STATE OF CONNECTICUT SITING COUNCIL

PETITION NO. 1398

PETITIONER LSE PICTOR LLC'S RESPONSES TO SITING COUNCIL INTERROGATORIES **DATED APRIL 21, 2020**

**SITE DEVELOPMENT PLANS
PROPOSED 1.99 MW SOLAR ARRAY
PLATT HILL ROAD
WINCHESTER, CONNECTICUT
PREPARED FOR LODESTAR ENERGY**

CROSS SECTIONS
SHEET 14 OF 15
PROJECT # 032-2019
SCALES AS NOTED
DATE: 5/1/2020

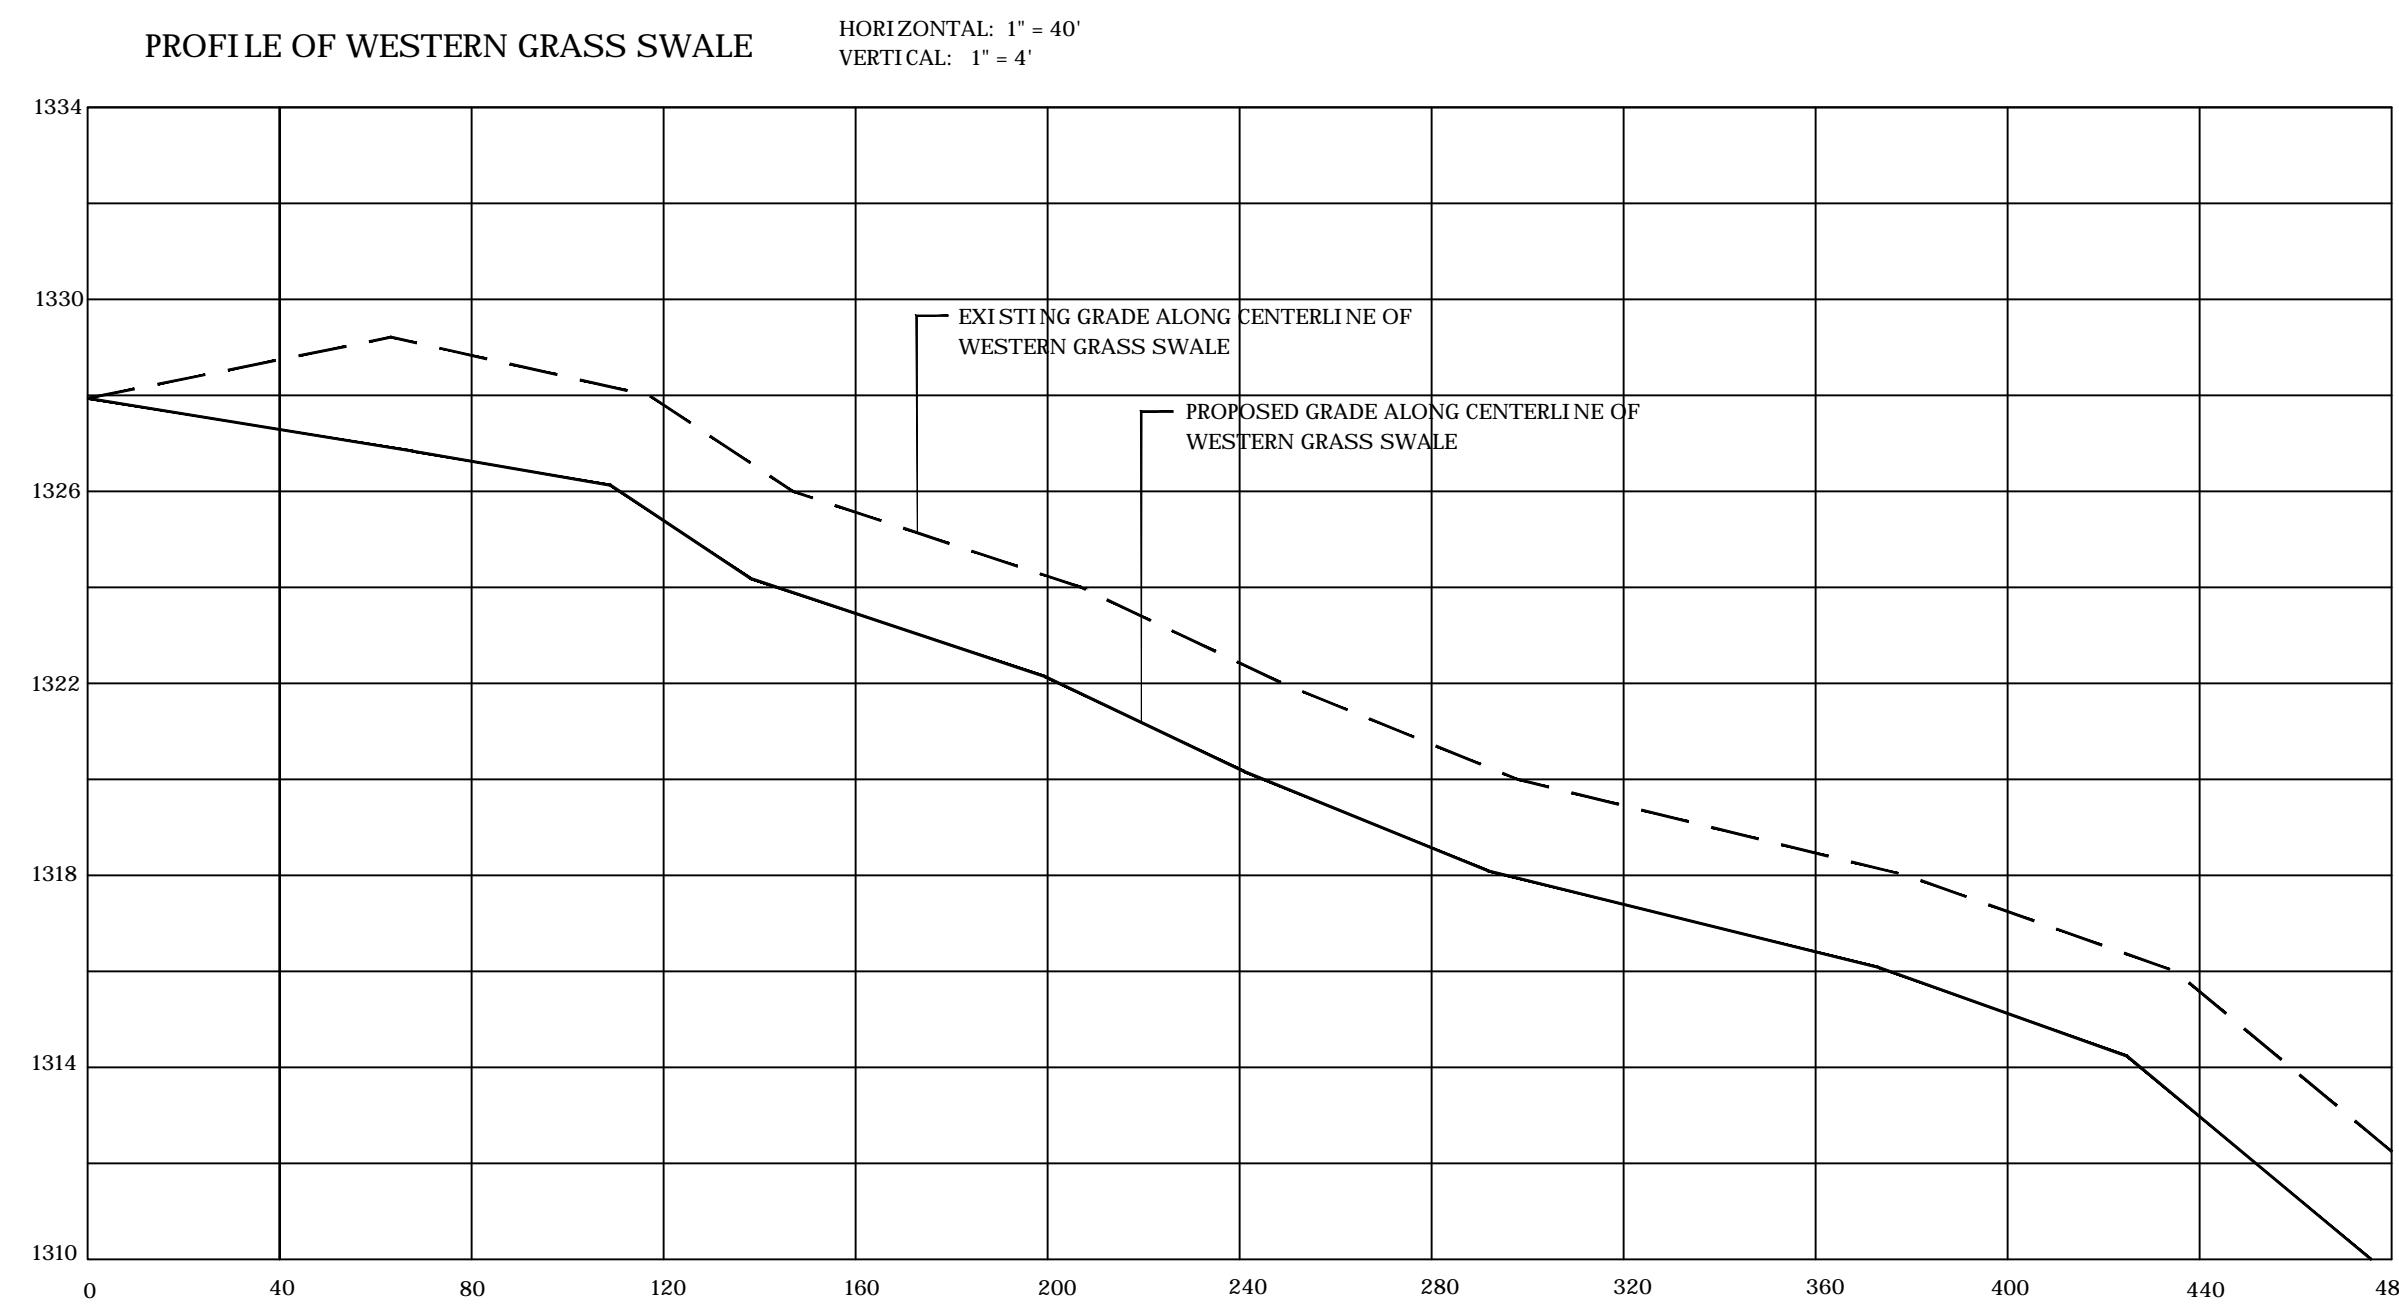
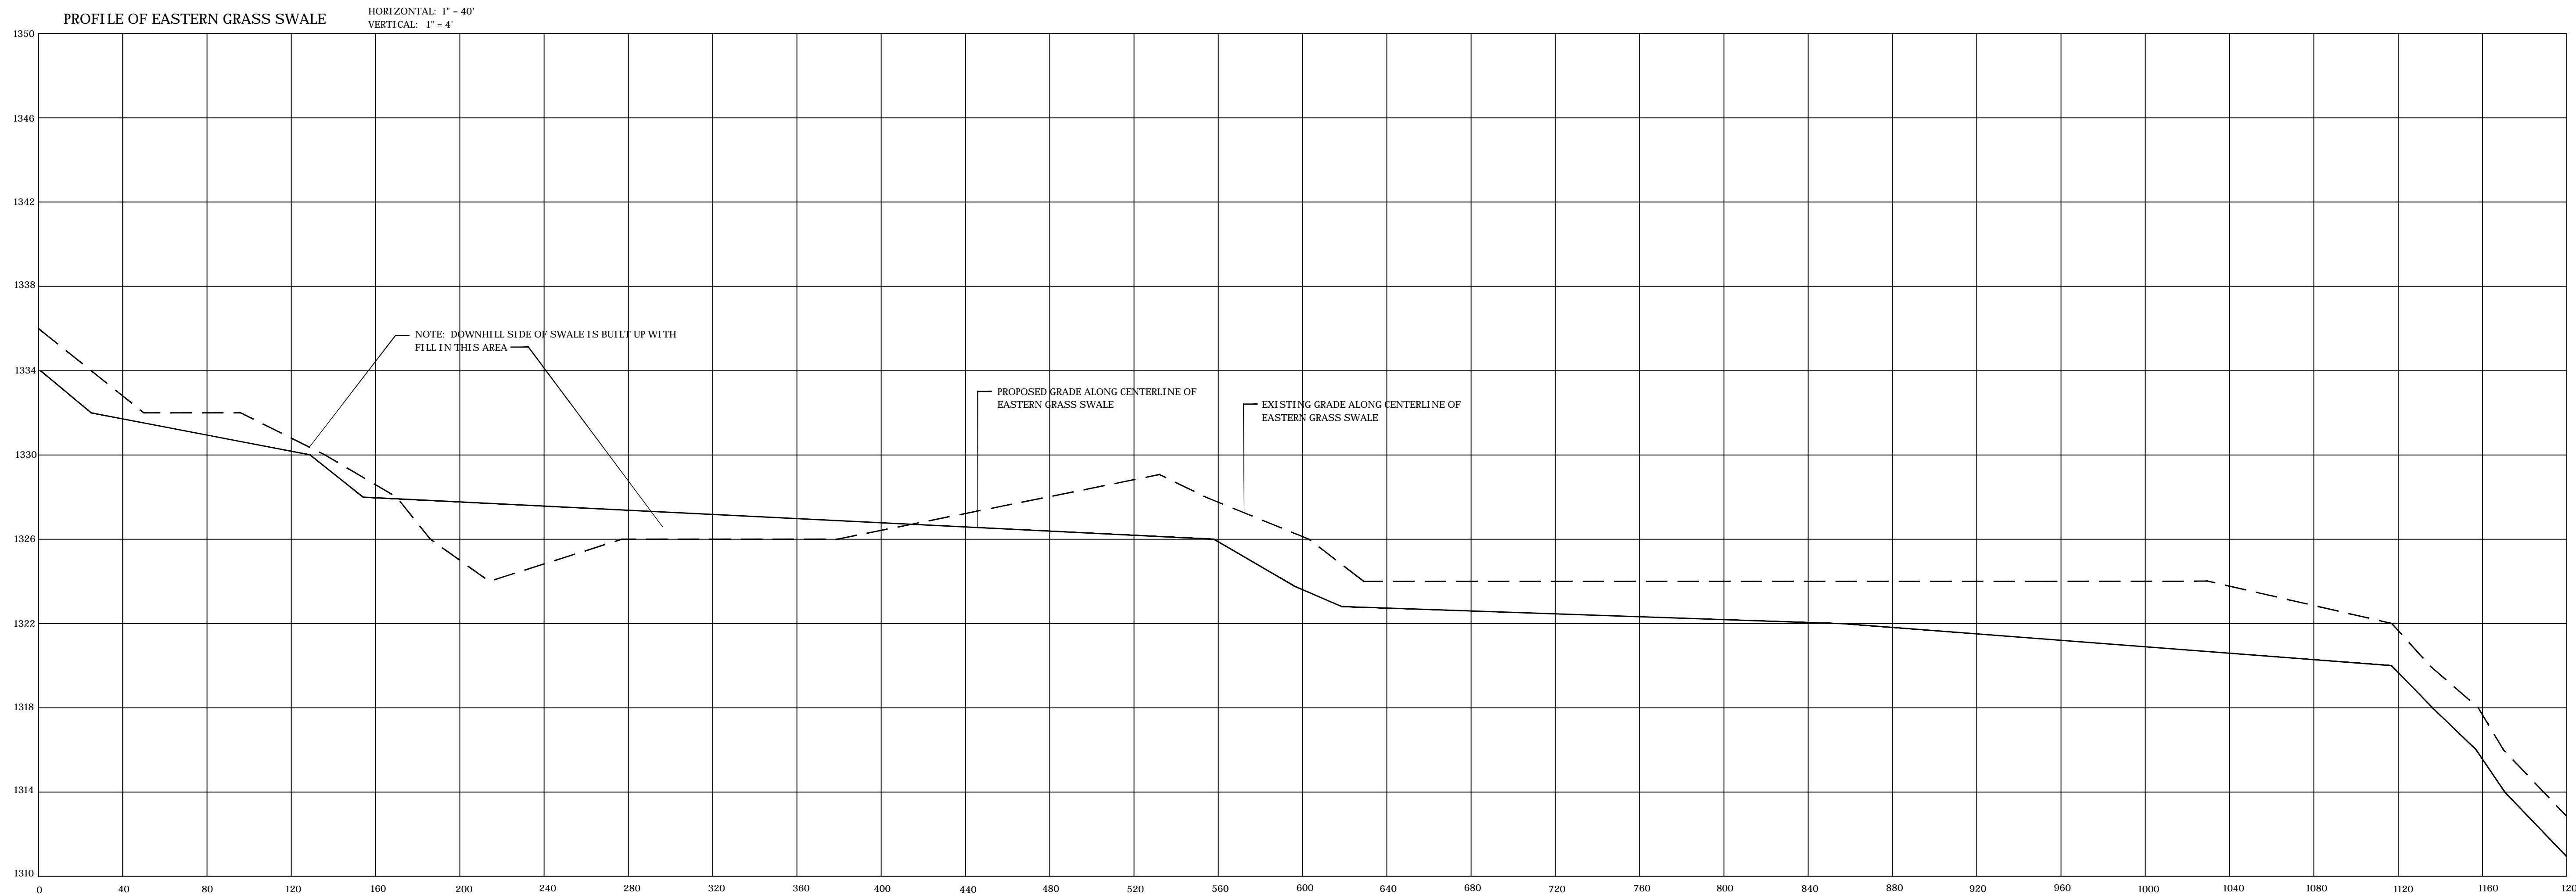
42. ***Provide a cross section detail of the proposed wetland detention basin.***

43. ***Provide a slope profile of the three proposed drainage swales. The design of the swale system shows the east and west swales meeting at the top of the larger swale- could high flow storms cause erosive forces that could result in swale failure or damage at the point where all three swales meet?***

Please see revised plans attached hereto as Exhibit A.

Please see revised plans attached hereto as Exhibit A. A section (profile) of each swale is being provided for the two (2) grass swales and one riprap swale. In preparing the section of the eastern grass swale, Petitioner determined that at one section south of the array would have more earthwork than initially anticipated. The alignment of the eastern grass swale was revised to more closely follow the existing contours. This slight modification does not affect the design or capacity of the eastern grass swale. The swale is an average of two feet (2') in depth relative to existing grade.
